Transmission Rules/Towers Review Working Group

Meeting Minutes – May 7th, 2015

Item 108 Conductor Swing Provisions in Rules and ID Document:

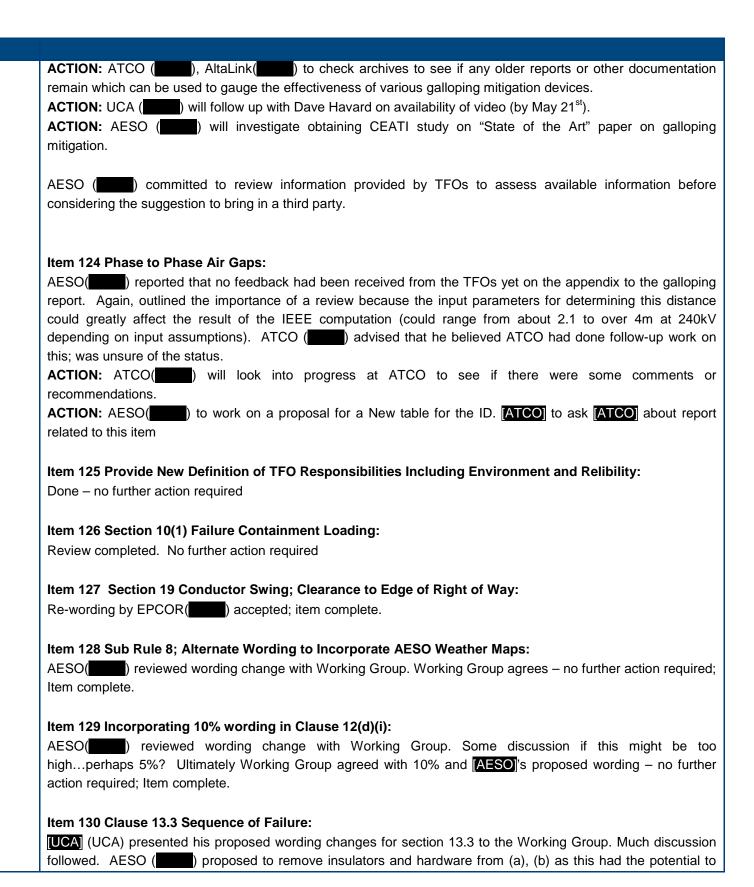
AESO (reported that EPCOR's (revision to Section 19 was inserted in its entirety, old section 19 removed. Some discussion of the revision by the WG; ATCO (requested removal of reference to "trees and high equipment" as they were covered with VCE's or not necessary. EPCOR (classed) clarified the "equipment" reference was more for communications towers and facilities (page, 25)

ACTION: AESO () – update Rules document removing both trees and equipment from section 19, inserting reference to towers.
